# SERVICE BULLETIN

No. 280

Subject: Case leakage of R. C. Allen 3" Artificial Horizon  
(See attached R. C. Allen Inc., Service Bulletin No. 1.)

ARTIFICIAL HORIZON

Figure 1. Application of Pressure Sensitive Tape.

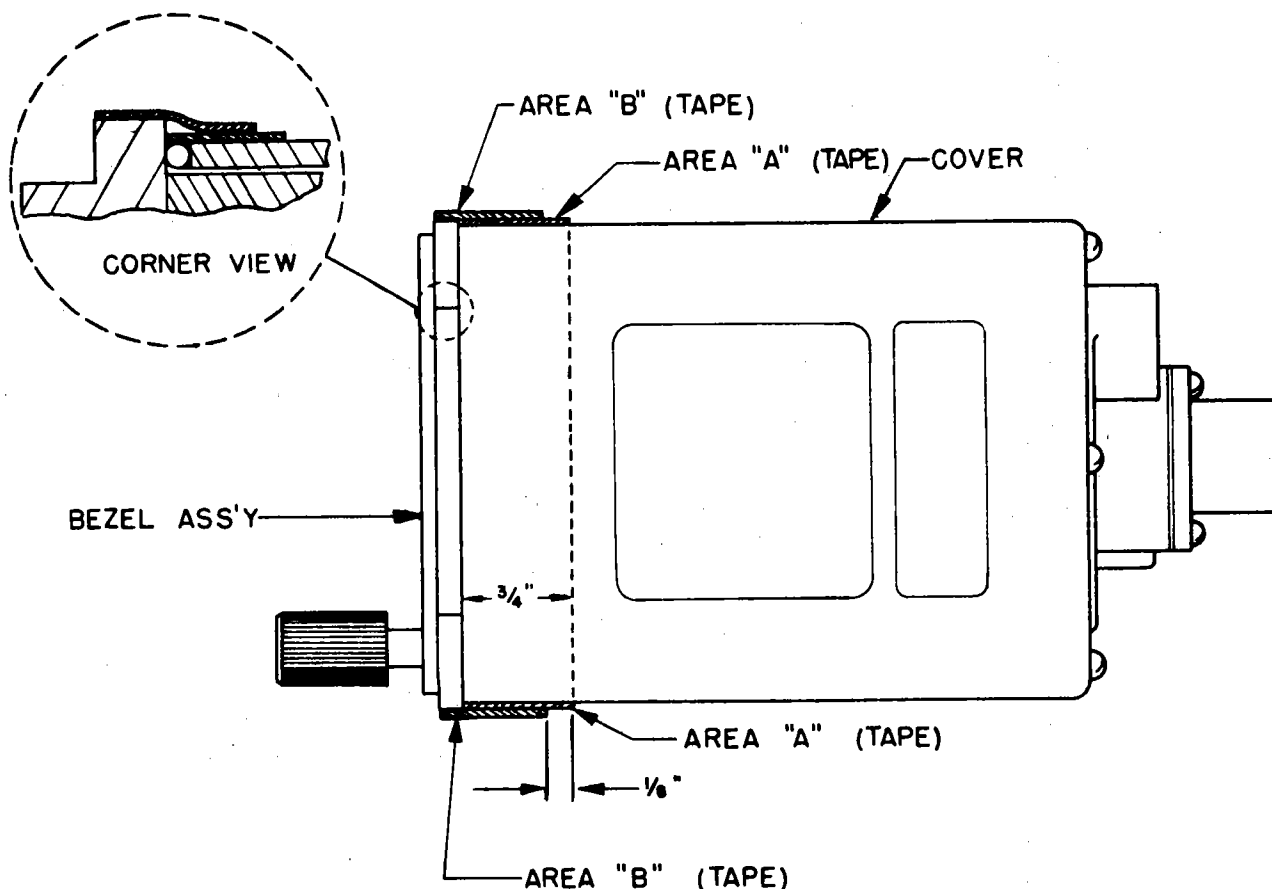
Some deterioration of the gasket used to seal the case to the bezel has been experienced. Such deterioration may occur due to the action of ozone and/or the action of certain solvents to which the gasket may have been exposed. If not corrected, the deterioration may result in leaks which can lead to reduction of vacuum system pressure, sluggish horizon performance and eventually complete failure of the gyro system.

In order to protect the gasket from deterioration and to provide a back-up seal, it is recommended that the procedure described herein be accomplished within the next 25 hours of operation of the aircraft. If reduced vacuum gage readings or sluggish performance of the horizon is noted, inspect for gasket failure immediately.

2. Refer to Figure 1 and apply one wrap of pressure sensitive tape, 3/4 inch wide, around the horizon as shown in Area "A". Pull the tape as it is being applied so that a slight amount of stretching occurs. The edge of the tape must butt against the rear surface of the bezel assembly and lay firmly against the cover. Overlap the tape approximately two inches.

3. Again refer to Figure 1 and apply one additional wrap of the tape over that just applied as shown in Area "B". Apply this wrapping so that the edge of the tape is flush with the front surface of the bezel assembly. Stretch as required so that the tape lays smoothly around the irregular corners of the bezel. Overlap the tape approximately two inches.
